ADDENDUM NO1-R1Date: **March 27, 2026**Project No.: **2596**Project: **Alderville Senior's Residence
Renovations**

ALDERVILLE SENIOR'S RESIDENCE RENOVATIONS

Date: March 26, 2026
Project: Alderville Seniors Residence
Renovation
Project No: 25-088
No: ADD-ME01

Date: March 26, 2026
Project: Alderville Seniors Residence
Renovation
Project No: 25-088
No: ADD-ME02

A-1.0

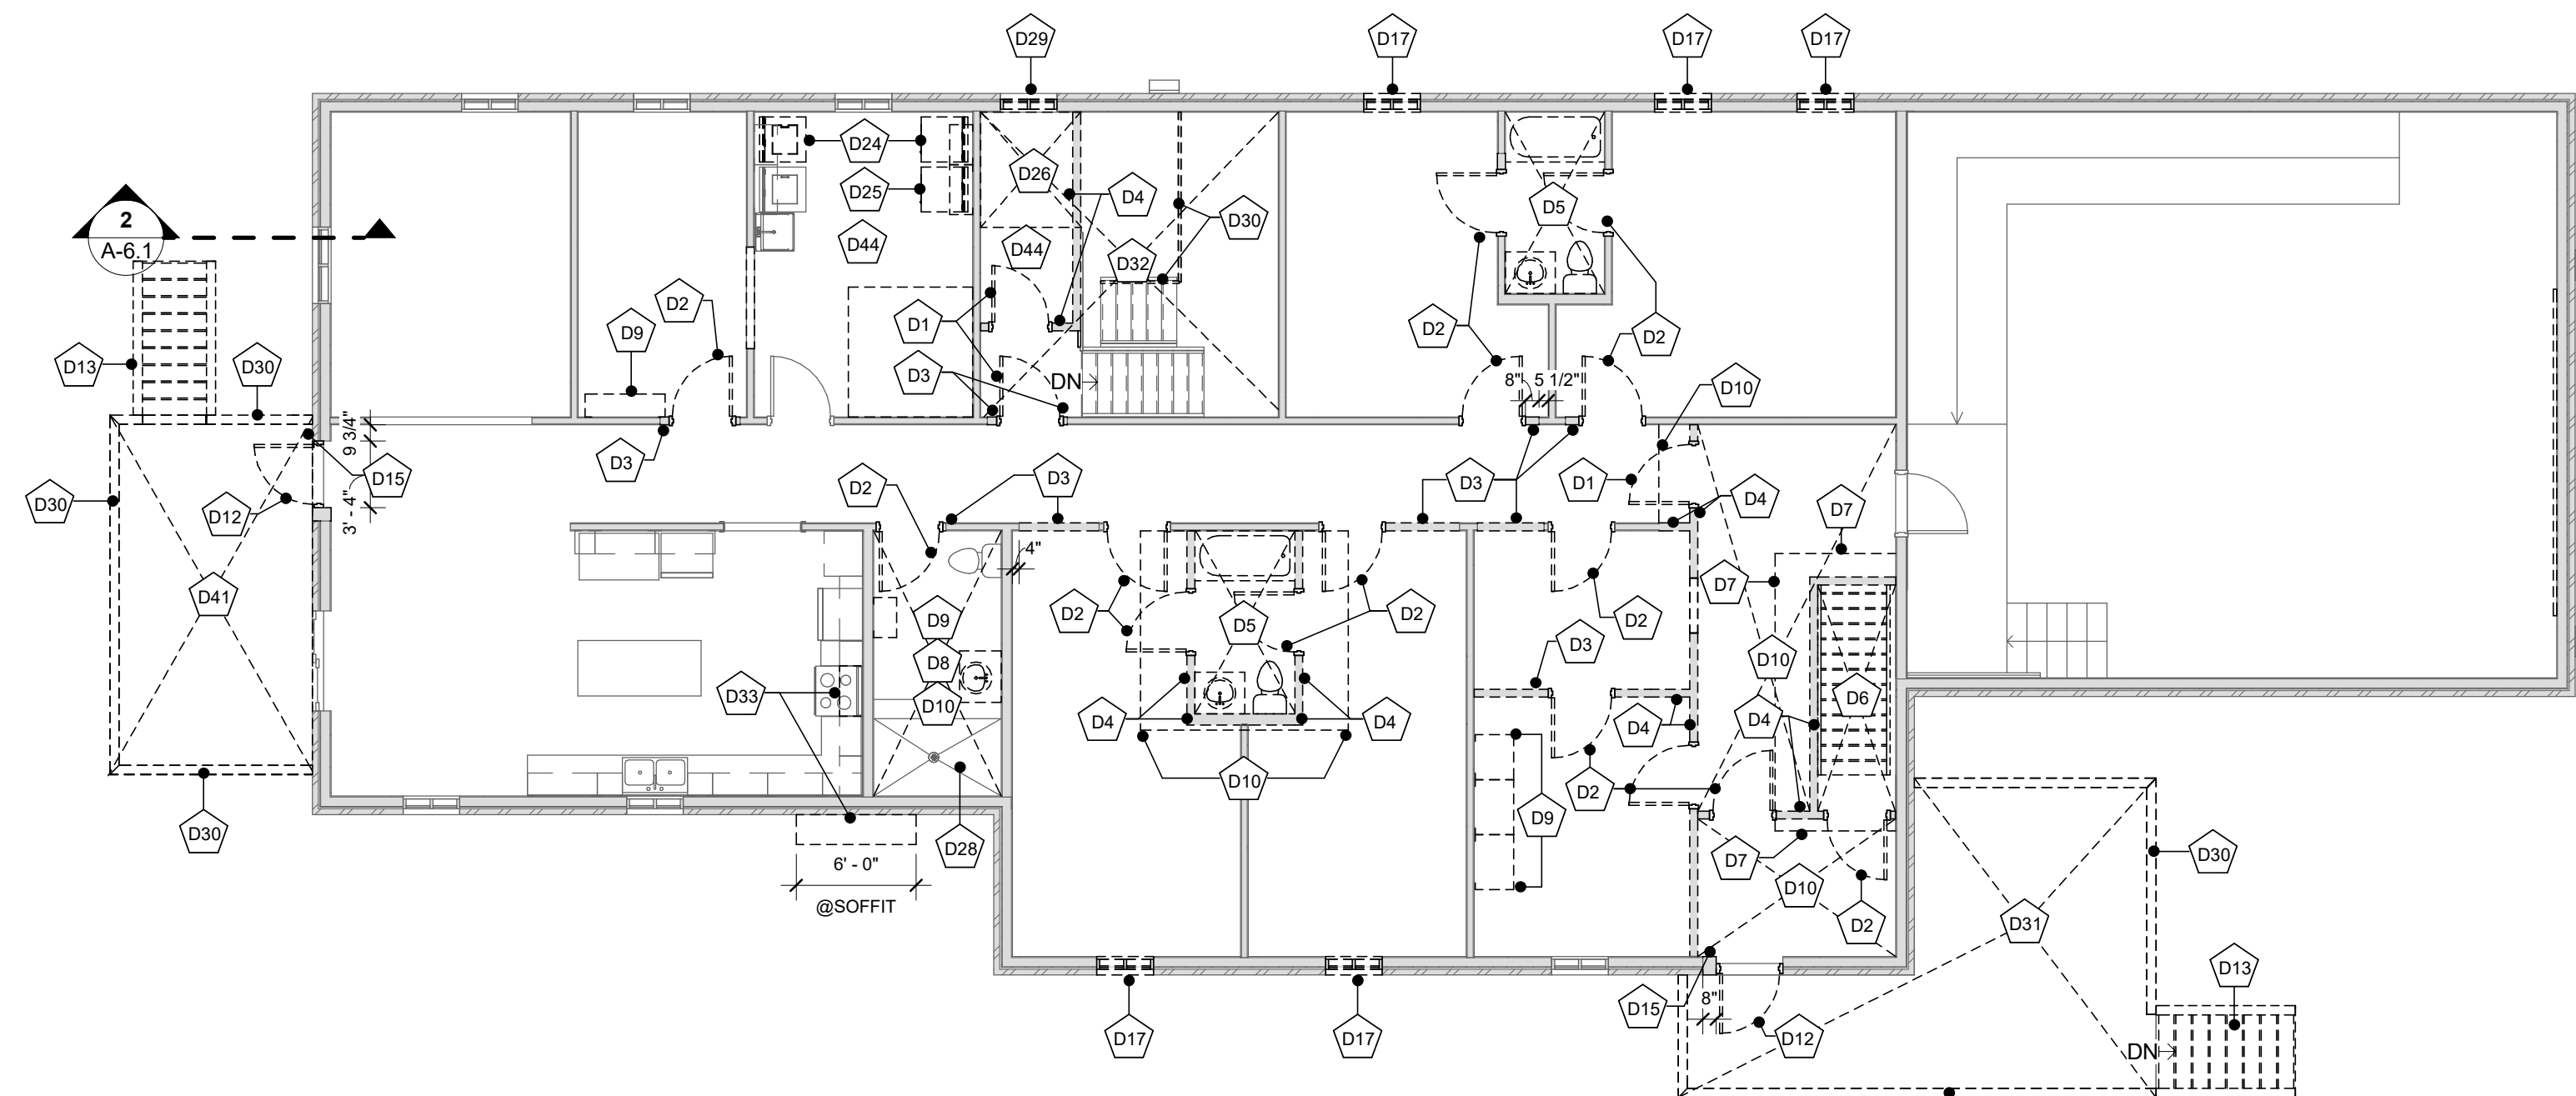
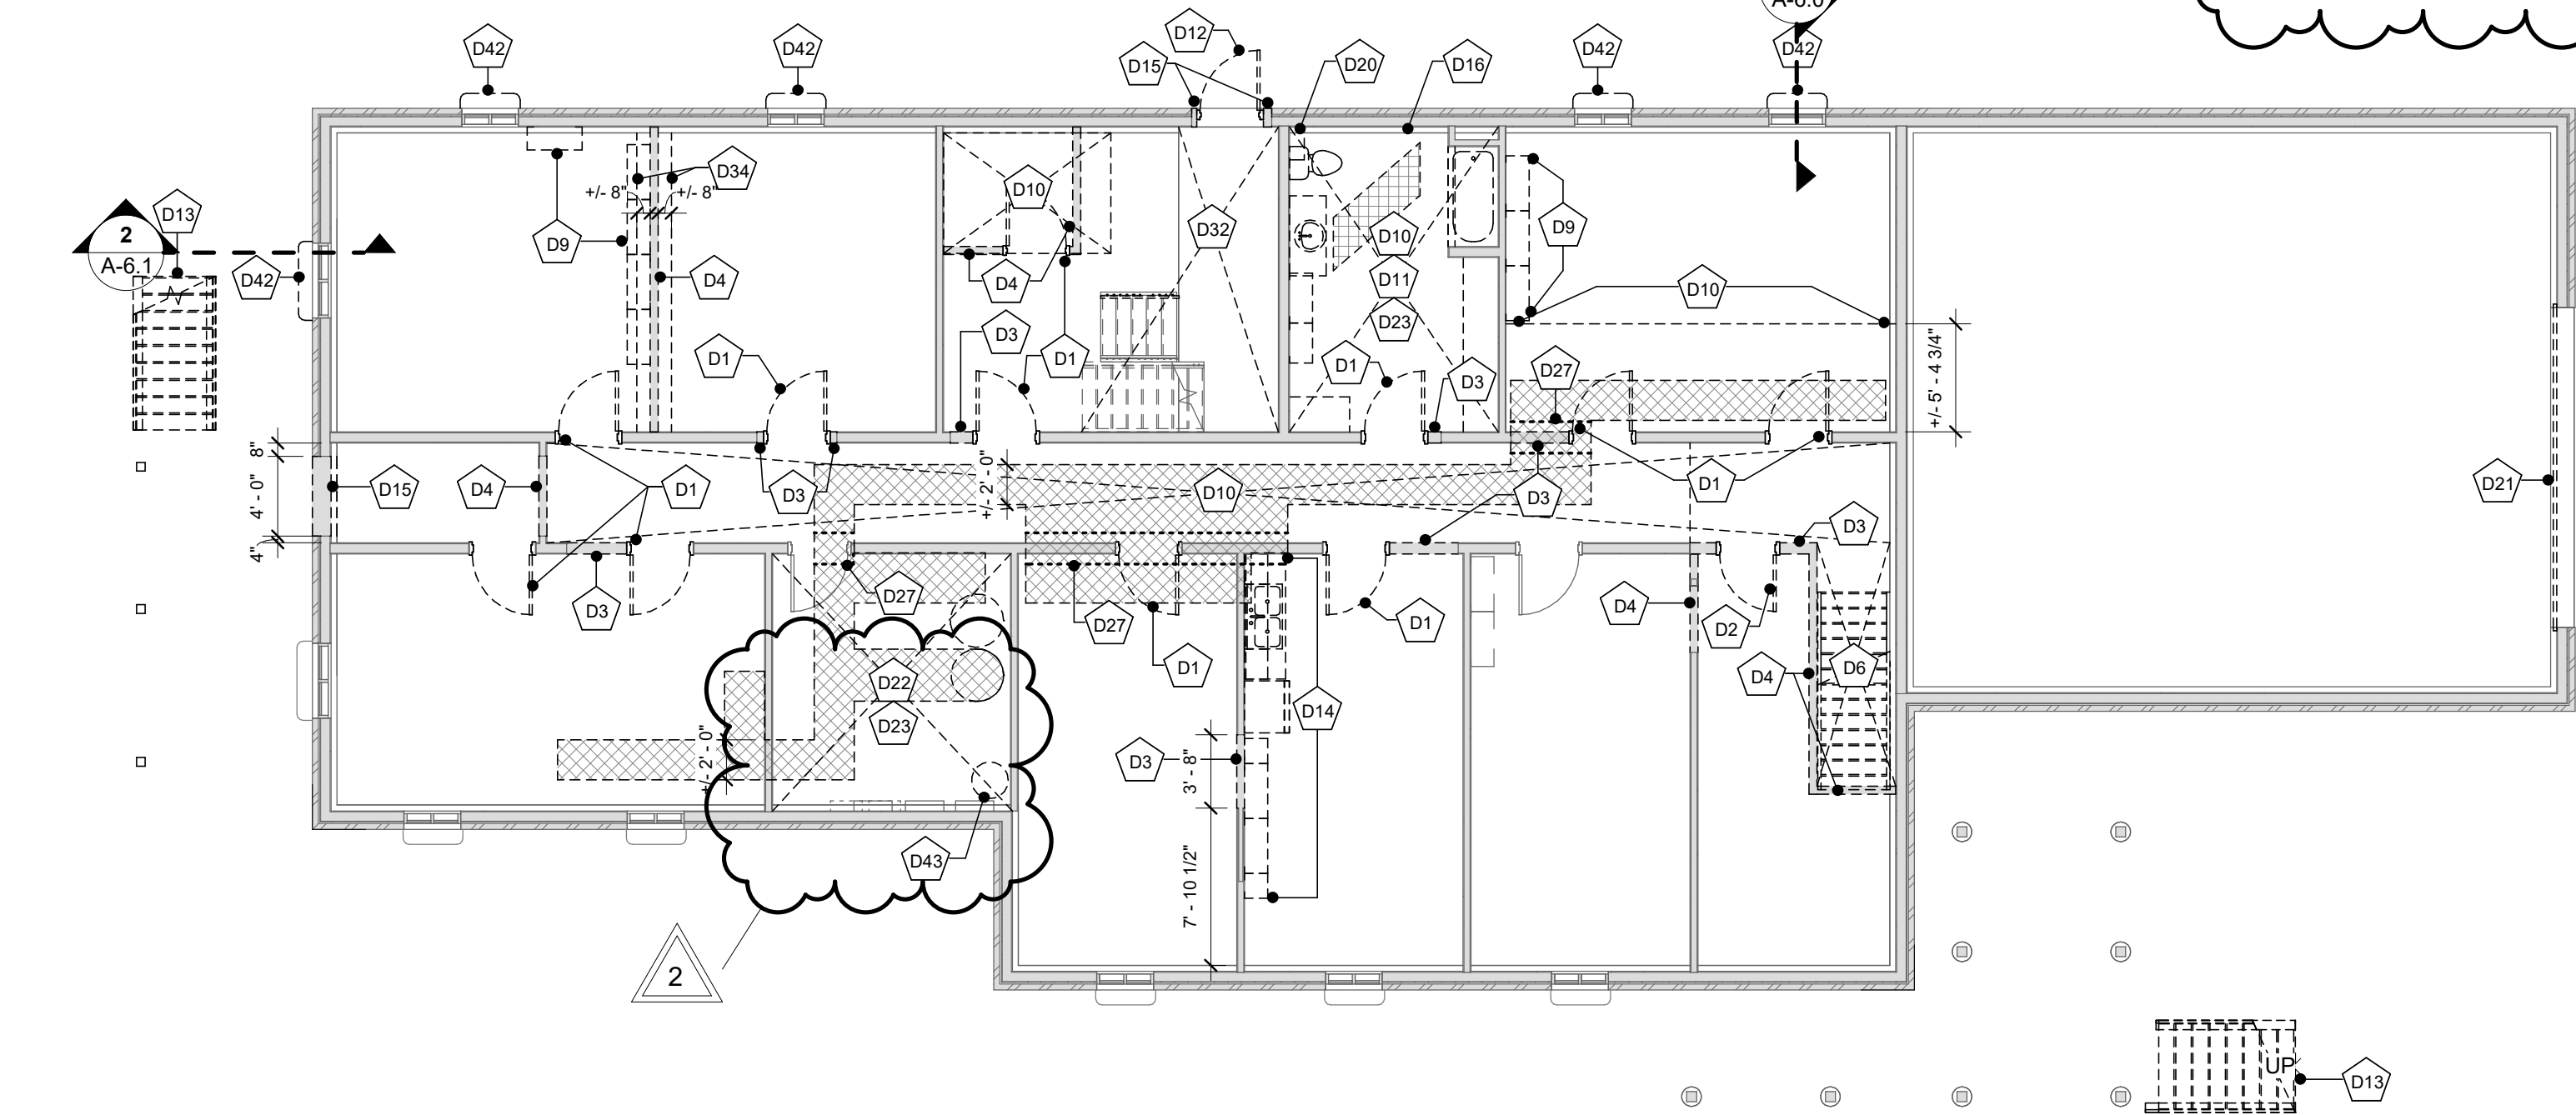
- 1.12** **Description:** Delete drawings SP-1, A-1.0, A-2.0 & A-7.0 in their entirety and replace with the following:

All changes have been bubbled.
